STAFF RECOMMENDATION

NCPC File No. ZC 07-18

CONSOLIDATED PLANNED UNIT DEVELOPMENT, 1000 F STREET, NW Square 347, Lots 18, 19, 818, 819, 820 and 821

February 28, 2008

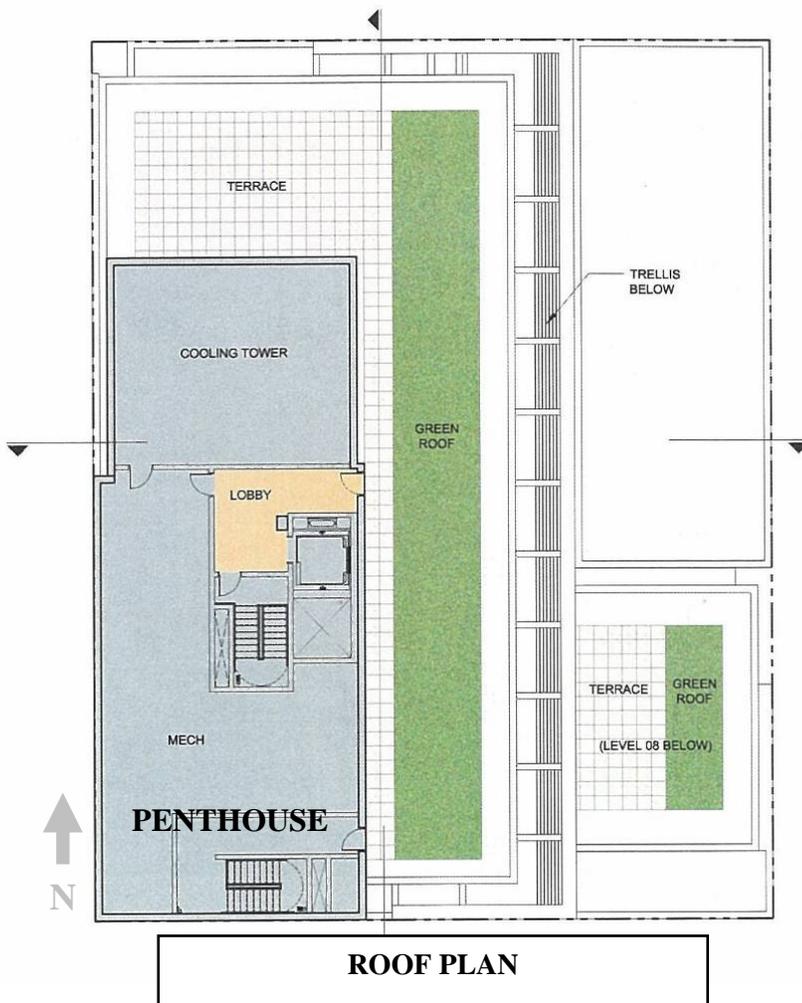
The Act states that "no parapet walls shall extend above the limit of height." This statement in the Act is unambiguous in its meaning and applicability. The PUD proposal is to construct a 120-foot tall building, to be measured using the 100-foot, F Street right-of-way. As shown in the detail to the right, the parapet is situated directly above the exterior wall on top of the roof, without a setback. The East-West Section shows that the 120 foot measurement is from the ground to the top of the roof and does not include the parapet. Staff finds that this parapet, as designed, exceeds the allowable height and therefore the building does not conform to the Height of Buildings Act.

Staff recommends that the Commission advise the Zoning Commission to require the developer to move the parapet wall back a distance from the exterior wall equal to its height in order to be in conformance with the Height Act.

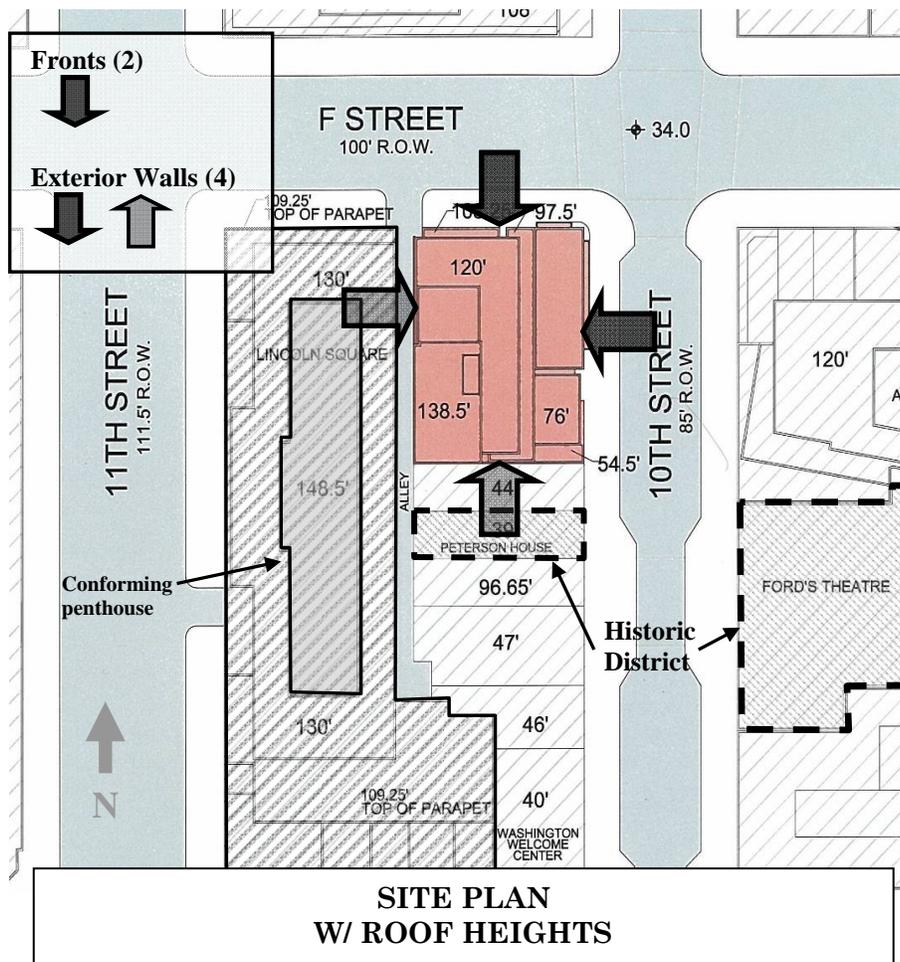
The second issue that concerns the Height Act is the penthouse setback. As the Roof Plan shows, the penthouse is set back properly from the northern and eastern exterior walls, but is not set back along the southern and western exterior walls. In the Consolidated PUD Statement, Exhibit #4, filed by the developer and dated June 19, 2007, the developer acknowledge this issue and request relief for the penthouse structure because, in their words, "the mechanical penthouse is not set back from the southern and western exterior walls." According to the Height Act, penthouses:

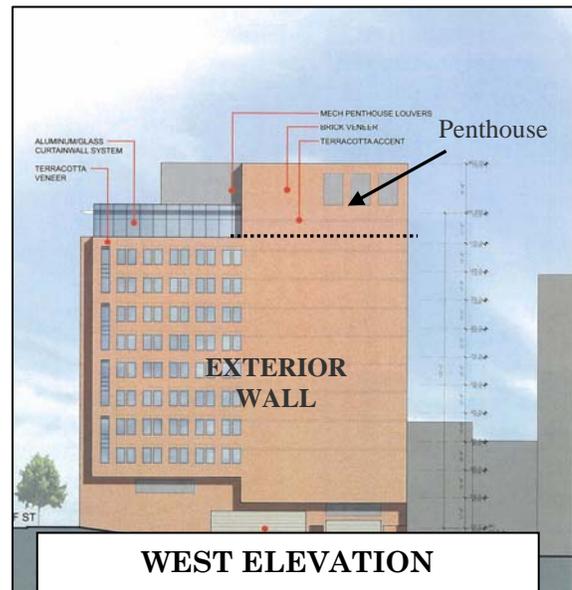
The adjacent building, 518 10th Street, located directly south of the proposed development site is a three-story, historic structure that staff believes likely will not redevelop given its location between the historic Peterson House and the new development. Therefore, staff believes this will remain a three-story building and the large masonry wall, shown in the South Elevation, will continue to be an exterior wall. Furthering the argument that this is an exterior wall is the developer’s South Elevation showing windows along most of this

elevation. As such, the Height Act's requirement to set back the penthouse should be enforced along this elevation as well.

Furthermore, the penthouse should be set back from the wall along the alley (West Elevation) because it is considered an exterior wall. As shown on the drawing on the previous page, the West Elevation includes windows along half of the elevation. As an exterior wall, the West Elevation is exposed to the weather, but the penthouse is not set back from the adjacent roof as required by the Height of Buildings Act. This set back should be enforced along this elevation.
